# BUCKINGHAM TOWN COUNCIL

INTERIM  
FULL COUNCIL

22/02689/ADP Land at Osier Way, MK18 1TG

Comments relating to Design Code submitted as part of revised details for planning application 22/02689/ADP.

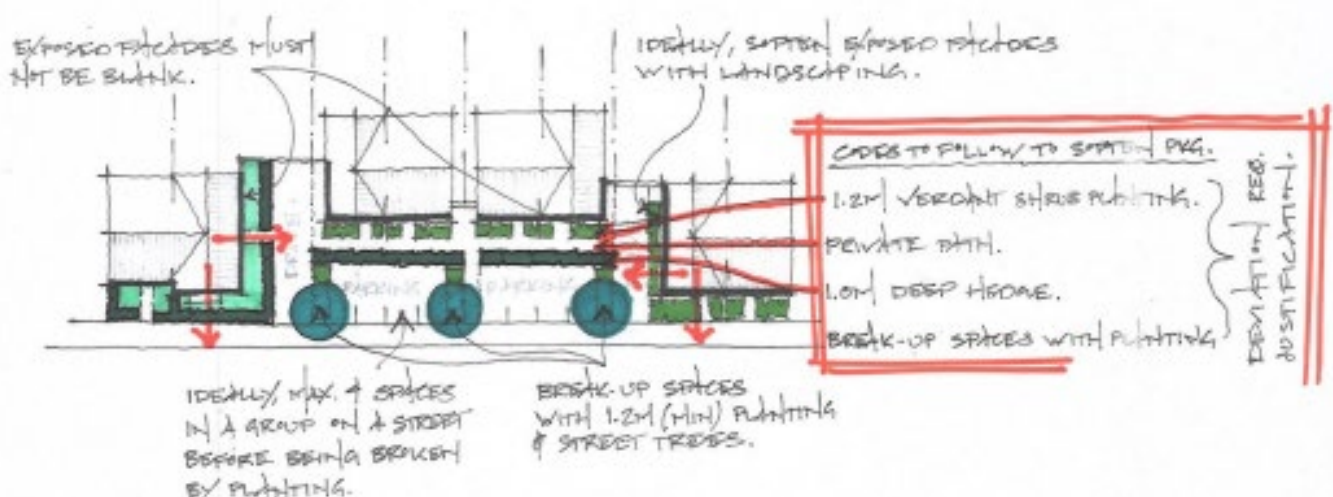
Example - no actual suppliers or colour names are included

Key Locations: The following must be adhered to unless justified otherwise: 100% Stock Brick. 100% Higher quality Roofing Material: - Slate (or Slate effect with thin leading edge). - Plain Tile (Duo Plain is acceptable). Chalk Render is acceptable.

Remainder of the Site: The following must be adhered to unless justified otherwise: 60% Stock Brick. 60% Higher quality Roofing Material. Chalk Render is acceptable.

## 8. Design Code: Principal Entrance (to this Phase) – "Southern Gateway"

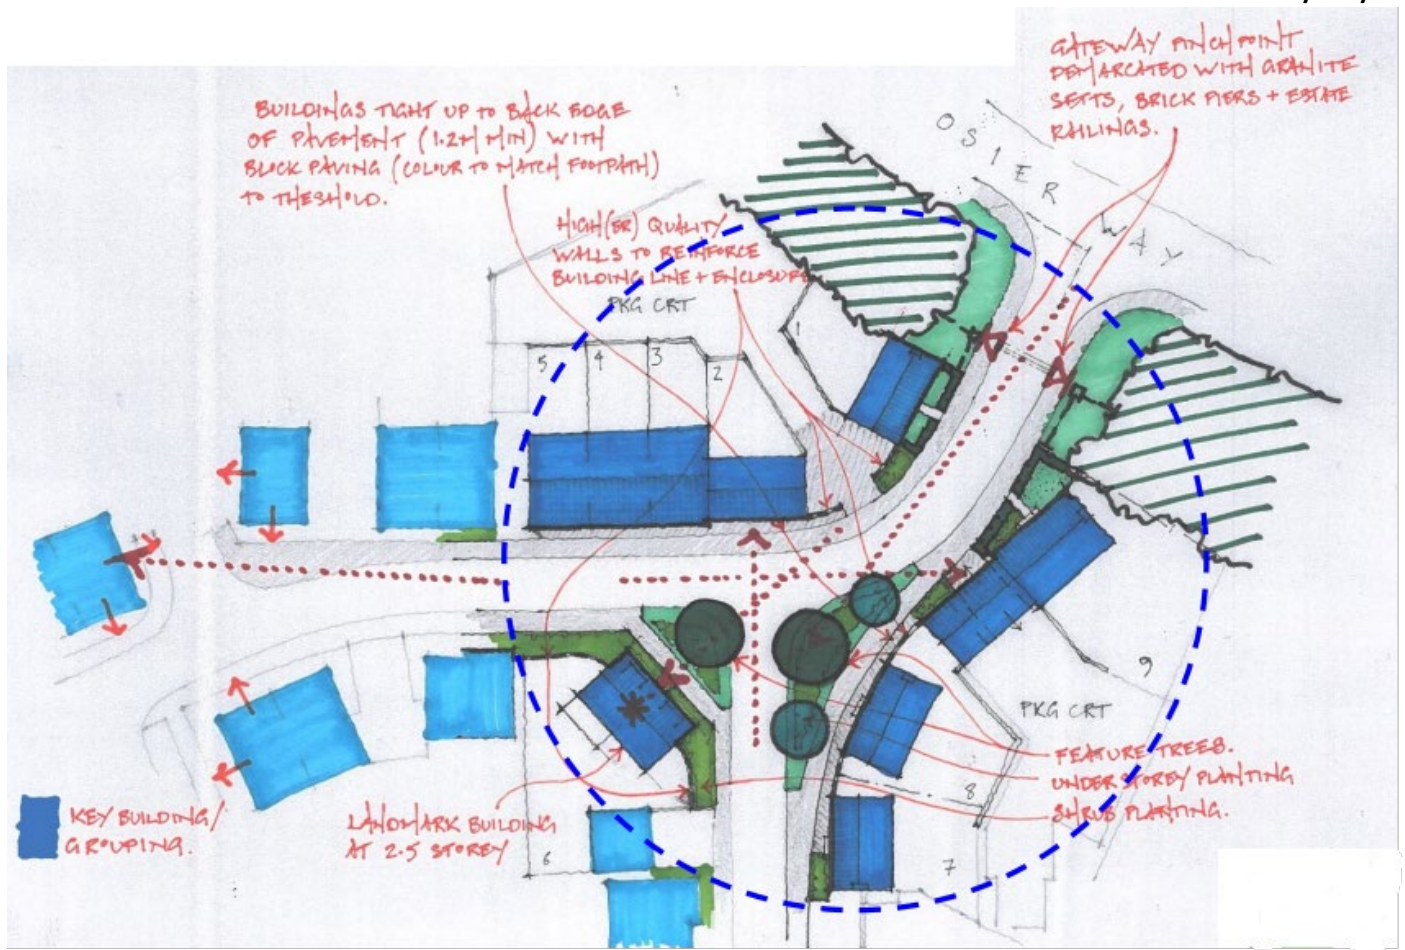
"The gateway into this sector should be an intimate arrangement of building all working hard to define the street and create the sweeping building line described in earlier sections of the Code. The composition of dwellings should seek to allow for generous street planting and terminate vistas with recognisably Buckingham (historic core) vernacular." [Notes 5, 6 & 7 to the diagram on p.3 apply]

## 9. The Amended Plans – Design Code: Play Space (whole estate)

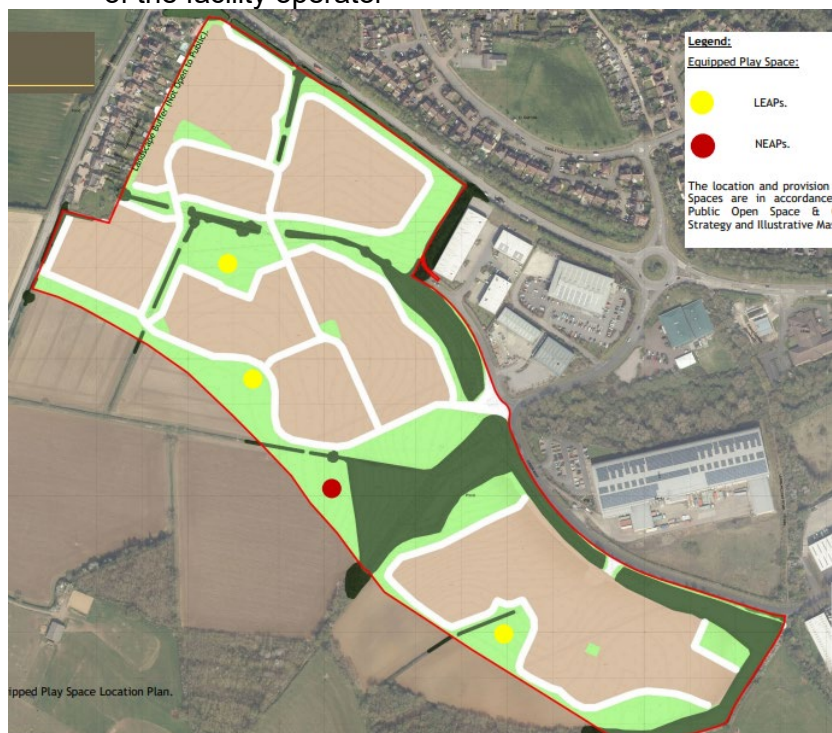
“Timber play equipment or that with a natural appearance should be used, this is especially important for the NEAP which is located on the periphery of the development adjacent to the countryside edge. The furniture in these spaces should be of a sensitive material to the edge of settlement location with a natural material, such as timber, being an obvious choice.”

These 121 houses will only have access to a LEAP until the remaining phases are completed. A LEAP is intended for small (say, up to age 6) children who are beginning to go out and play independently and should:

- Be within five minutes’ walking time of any house it serves *[the straight-line distance to the furthest house is c250m; adult walking pace is c.4kph (1000m in 15 minutes) so this is met for adults]*

- Be positioned by a pedestrian route that is well used *[the ‘pedestrian route’ is the perimeter path which goes through a gap in the retained hedgerow – the diagonal green line beside the yellow dot in the plan below; how ‘well-used’ this will be remains to be seen]*

Note that these are the only 'community facilities' on offer for the total 420 houses. The Design Code calls the green area around the LEAP on the spine road the Primary Node and describes it thus:

*Members might like to enquire what other 'popular facilities' might be accommodated, in case the bus service does not materialise (as Lace Hill's hasn't, yet).*

## 10. The Amended Plans – Design Code: Public Open Space (whole site)

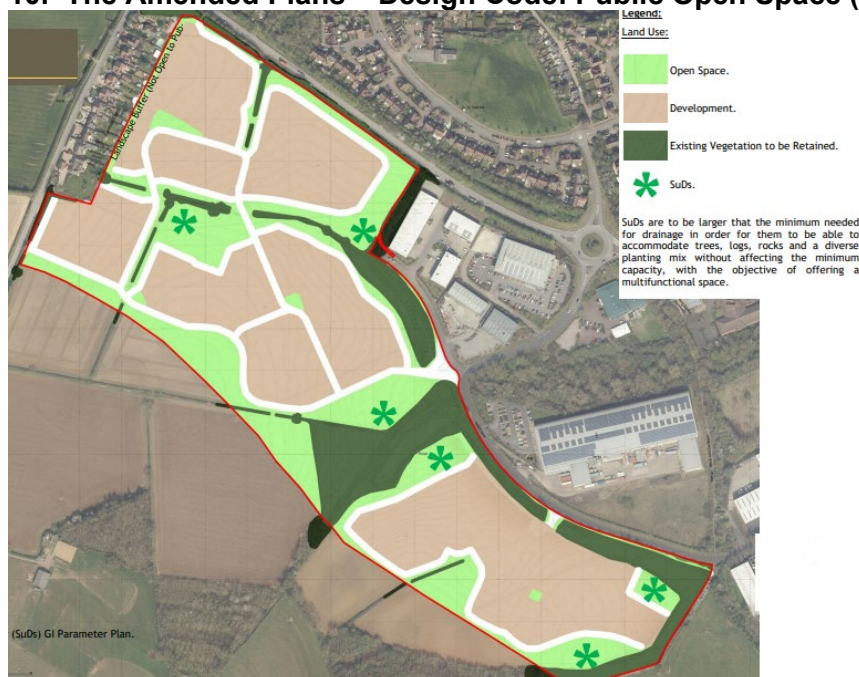
The isolated green spot in Phase 1 is Incidental Space 2. See below for details of what this amounts to.

Southern Sector - Incidental Space 1.

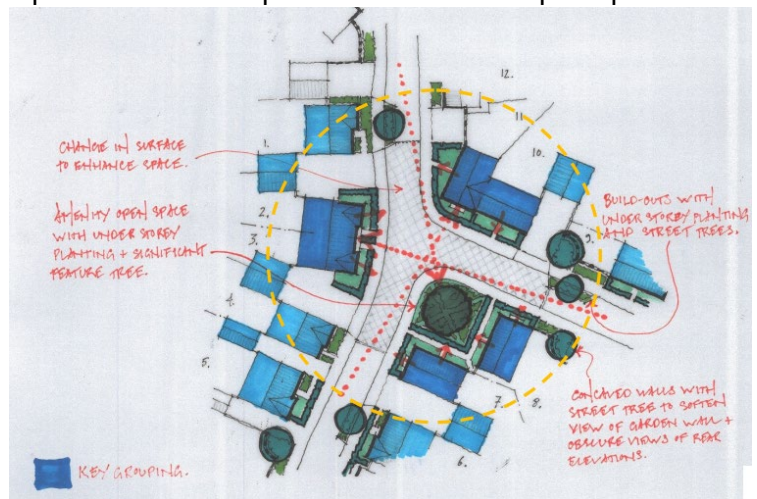
"The existing hedgerow to be retained along with the BNG [Biodiversity Net Gain] and LEAP area in this locale present[s] a complex space to design. Therefore, it is important to create a collection of dwellings and landscape features around the junctions and entrance into the open space that is thoughtfully considered to terminate vistas, enclose space and provide a landscaped entrance to the open space."

Figure 4.2: Indicative area of thinning & removal of Southern shoreline.

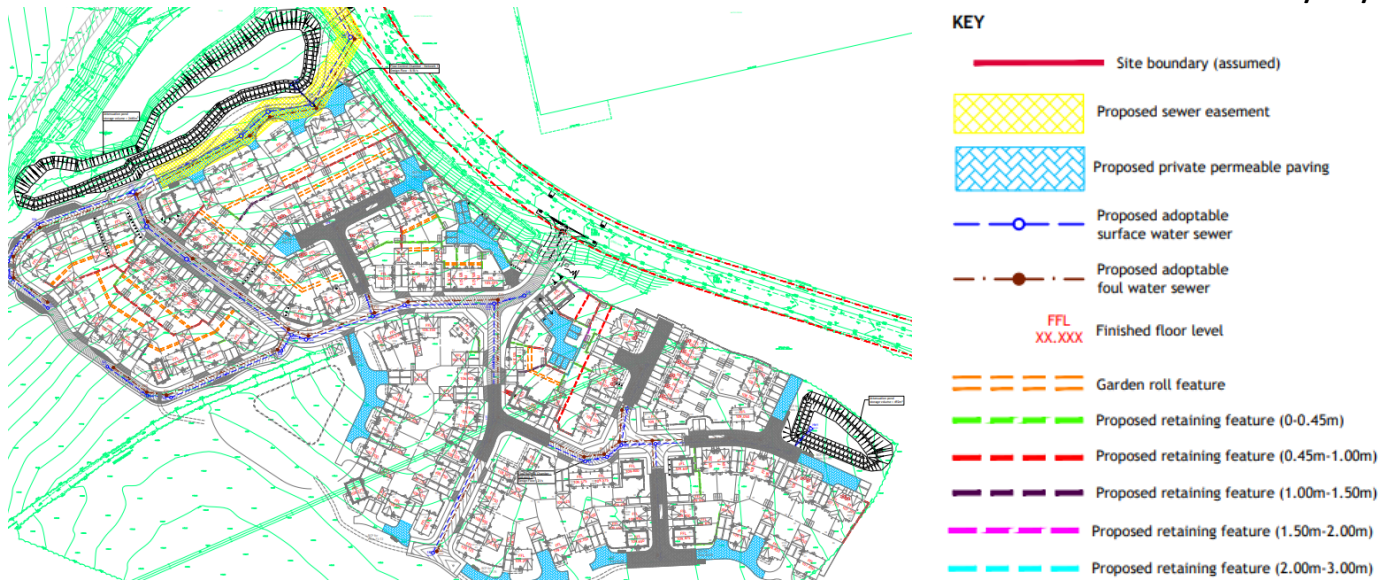
*Part of the ploughed area to the right of the red outline is to become an attenuation pond, so I suppose 'shoreline' is a legitimate term.*
